Project	IEEE 802.16 Broadband Wireless Access Working Group < http://ieee802.org/16 >	
Title	UL subframe duration unspecified for FDD mode in OFDMA	
Date Submitted	2004-08-18	
Source(s)	Intel.	
	Yuval Lomnitz	Yuval.Lomnitz@intel.com
	Yigal Eliaspur	Yigal.Eliaspur@intel.com
	Dov Andelman	
Re:	IEEE P802.16REVd/D5-2004	
Abstract	UL subframe duration to be included in UL-MAP in OFDMA	
Purpose	“	
Notice	This document has been prepared to assist IEEE 802.16. It is offered as a basis for discussion and is not binding on the contributing individual(s) or organization(s). The material in this document is subject to change in form and content after further study. The contributor(s) reserve(s) the right to add, amend or withdraw material contained herein.	
Release	The contributor grants a free, irrevocable license to the IEEE to incorporate material contained in this contribution, and any modifications thereof, in the creation of an IEEE Standards publication; to copyright in the IEEE's name any IEEE Standards publication even though it may include portions of this contribution; and at the IEEE's sole discretion to permit others to reproduce in whole or in part the resulting IEEE Standards pu

Figure 49—Minimum time relevance of DL-MAP and UL-MAP (FDD)

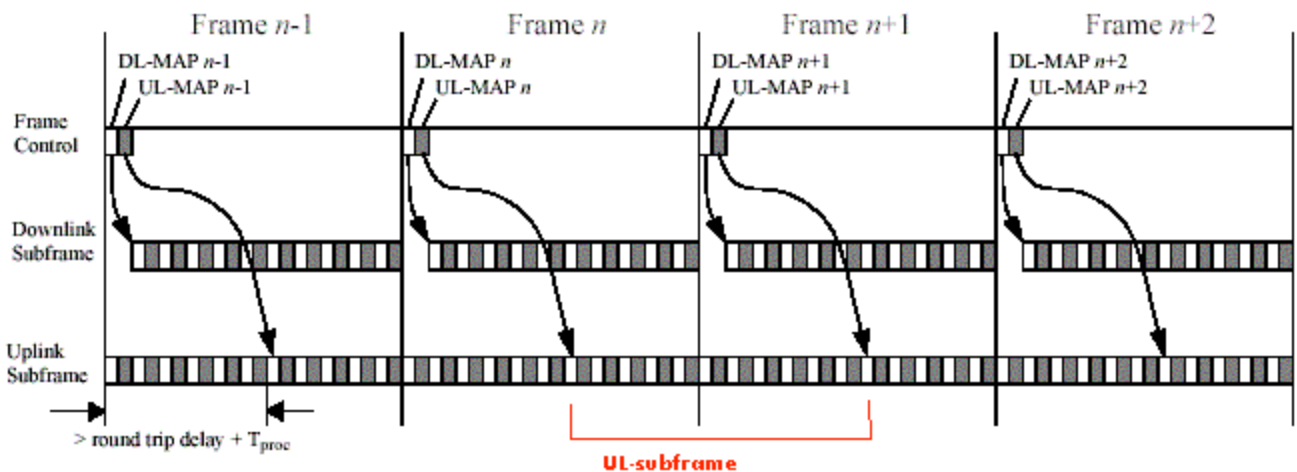
In other PHYs, the SS doesn't need to be aware of the dimensions of the UL subframe in order to transmit. Therefore in FDD, it only needs to know when to transmit. The UL-subframe may float in time in relation with the frame, as depicted in 802.16REVd/D5, Figure 49:

My addition in red clarifies where the UL-subframe is located (UL-subframe in the sense of all the UL transmissions indicated by a single UL-MAP).

As opposed to other PHYs, where a UL-subframe is only a virtual entity, composed of all the transmissions of different users, in OFDMA the UL-subframe is an integral entity, and all transmitting SS-s must be aware of its structure and size.

Therefore the length of the UL-subframe must be indicated. Since this may be a dynamic parameter, we suggest to indicate it in the UL-MAP. In addition, since the UL may include several zones, we propose to indicate the size of the first zone on the UL-MAP (and length of successive zones will be indicated in ZoneSwitchIE).

The change we propose is that the number of symbols in each zone (= the default zone, the AAS and the permutation zone), will be given in the IE that starts the zone. Specifically, the length of the default zone will be given in the UL-MAP header.
